2 New Street East, Balgowlah NSW 2093 Lot 12; DP 12383

DA 2025/0088

**Response to Landscape Referral: Dated 13.02.2025**

Image 5. Existing and Proposed Fence and Gates. The extent of fencing is modified by the carport and gate, but the character of the fence is compatible and relative to the neighbouring site, No.1 to the East.

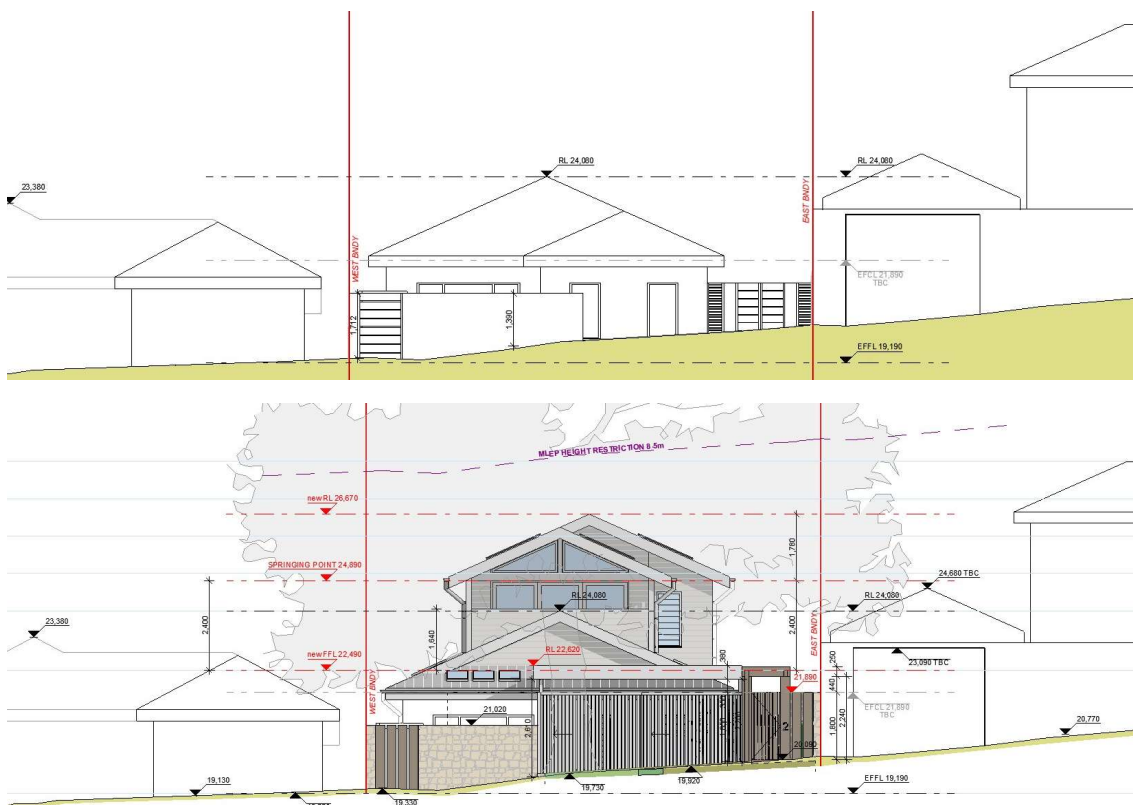
**Item 2.** Driveway Gates and Pedestrian Gate: We think the proposed height is suitable and not out of context in this scenario. The character of the street is not being compromised. Many fence heights in the immediate area are of varying scale, and for the purpose of a Carport and Entry Portico we feel this fence height proposed is not contravening the objectives of the DCP 3.3.1 Landscaping Design, and 4.1.10 Fencing. Reference should be made to the Statement of Environmental Effects. We would like this point to be given some consideration under 4.1.10.1 Exceptions to the maximum height of Fences. As we do appreciate the neighbouring property is a Corner Site and the fencing to that particular site facing New Street East is considered a 'Rear Boundary Fence', we do think that the proposed design refers to that and appropriately addresses the composition of function and setting with a direct relationship to the context of the surroundings. The roadway and site are sloped from West to East. Grading the fence height to follow that slope would result in a very similar top of wall point at the Eastern Boundary. The vehicle gates are proposed at a height that is compatible to the nature and function of a carport. The gate will offer an appropriate secure solution. It is important to understand that the proposal is not matching the height of No. 1 Gourlay Avenue, it is reduced by over 1.2m below the Carport Opening and Side Pillar. The style of fencing in New Street East has a straight plane consistency, with fence heights staggered defined by the slope and function of access including carport or garaging. The design therefore is generally consistent. Analysis below and continues on the following page/s.

Image 11: Extract of Plan DA-105, Schedule of Areas Plan.

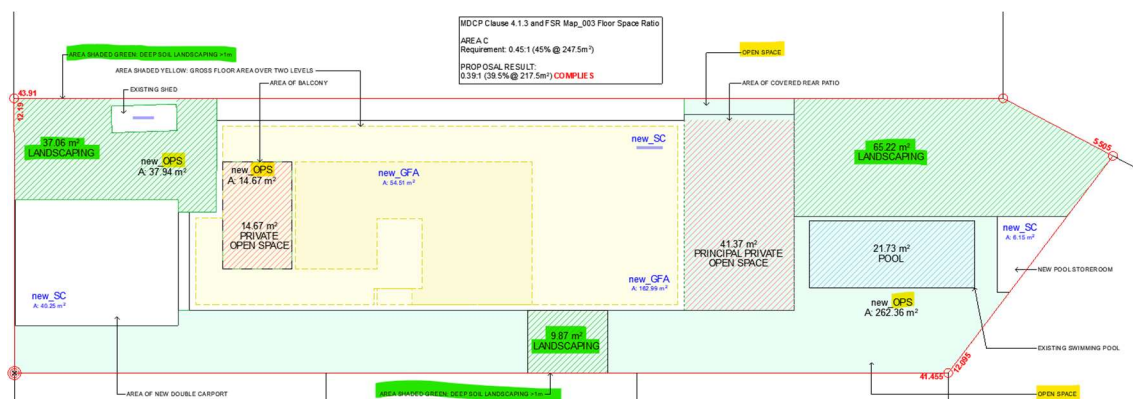
**Item 3.** The Landscaped Area: The Deep Soil Landscaped Area is compliant at 37.06% of the required Open Space Area. The required Open Space Area is set at 55% (OS3) of the site Area (550.1m<sup>2</sup>), calculated to be 302.55m<sup>2</sup>. The Eastern side pathway is part tiled / part planting, with a designated gravel/pebble bed that is to be wholly pervious. The Eastern Side pathway, under the definitions of the LEP is considered Open Space Area. This is shaded in Green on the Proposed Schedule of Areas plan, drawing DA-105.

The areas designated for sheds, carport and storeroom have not been included in the OPEN SPACE AREA. The Eastern Side Path has been included in the OPEN SPACE AREA, and by definition under the LEP, un-enclosed pedestrian walkways and access paths are permissible.

There is no roofing proposed over the Pedestrian Walkway. An awning does align over the entry door, at an area of 4.1m<sup>2</sup>, but is only offering shade and cover at an entry point.

The Hatched Green areas are Deep Soil Areas that have the **ability** to have grass, plants or trees. The Eastern Side area designated as Deep Soil Area is measured at 9.87m<sup>2</sup> and will be installed as a pebble bed. This is permeable area with space and measurements defined to function as Deep Soil Area under the DCP.
